**From:** Scala, Mary Joy  
**Sent:** Friday, May 24, 2013 11:57 AM  
**To:** Mark Van Sickle (MVanSickle@littleonline.com)  
**Cc:** 'stephen.hruska@lincolnharris.com'; Shane Brandwood (SBrandwood@littleonline.com)  
**Subject:** BAR Action 1619 University Avenue

**Certificate of Appropriateness Application**

BAR 13-05-01  
1619 University Avenue  
Tax Map 9 Parcel 102  
Stephen Hruska, Applicant/ Sovran Bank, Owner  
Site demolition and ADA Renovation to front sidewalk area

3. SITE LAYOUT PLAN

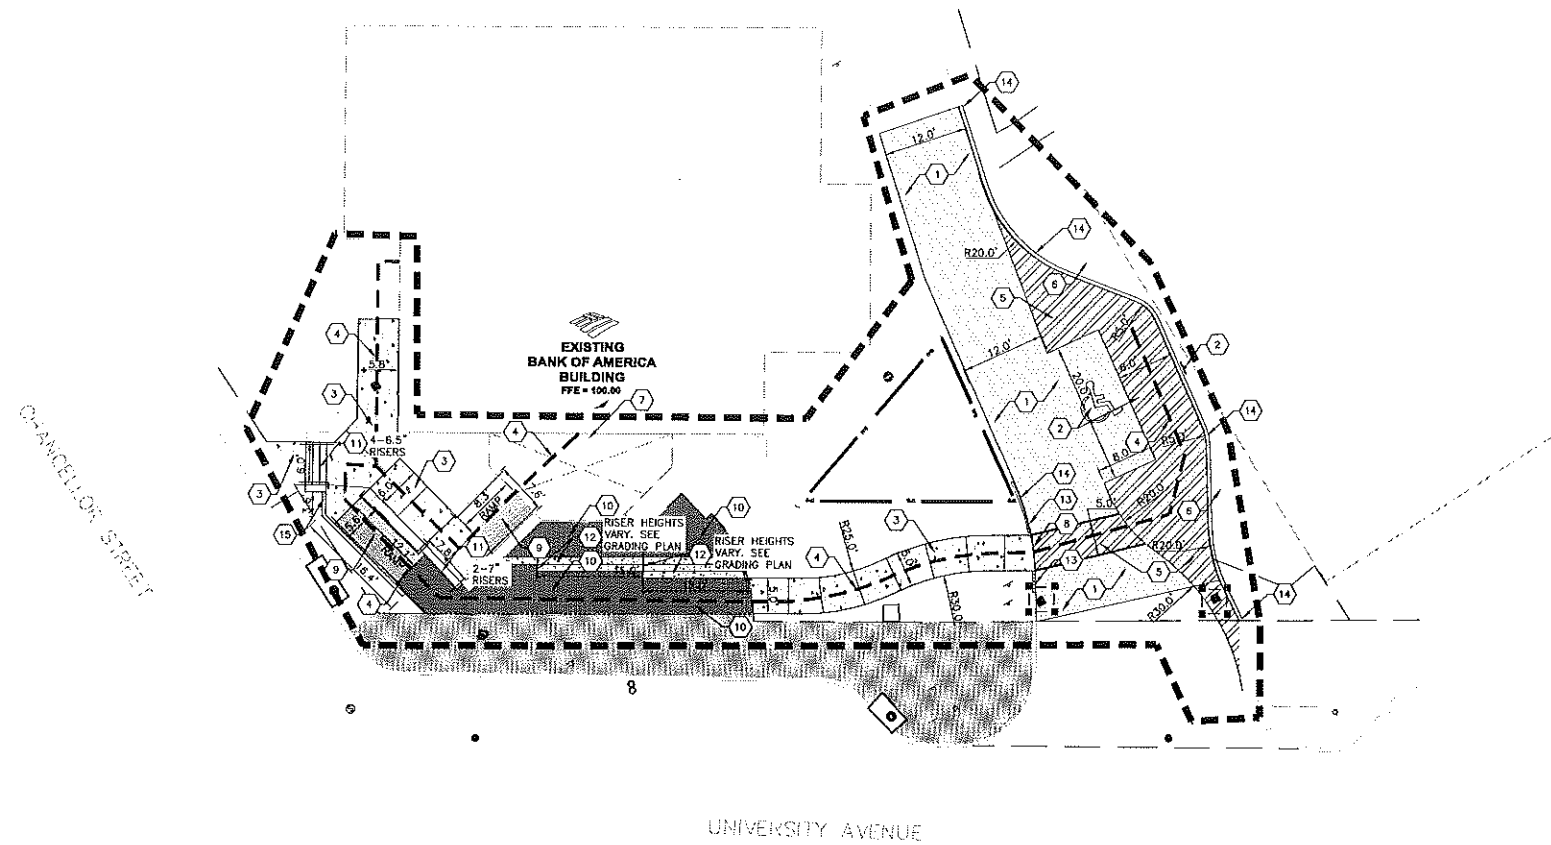
**Accepted (8-0) applicant's request for deferral. Revised plan should further develop the drawing submitted at meeting; brick walls at consistent horizontal level; lose the picket railing; look at framing concrete travel ways with brick, and coordinate with stone tread steps/brick risers; straighten path; clean up landscaping under tree; keep upper diagonal path on east side; use red brick [Old Virginia] pavers instead of dark brick, and consider polymeric sand.**

It seems like the area is becoming overly complicated ...odd new steps are being added directly in front that seem unnecessary and a trip hazard as designed.

The handrails should match or be coordinated with existing rails.

The reason for this project is that the current site does not meet ADA standards. There is currently no accessible route from the Accessible parking to the entrance of the building. Several alternatives have been explored during the design process and this design was the least intrusive to the site and existing building. The only landscaping that will be affected will be the lirioppe as shown in the perspective. Do we still need a separate landscape plan if the landscaping is not being affected? The handrails will match the existing and the brick pavers will match the current city standard as shown in the perspective image. If you have any more questions or need to discuss further please give me a call.
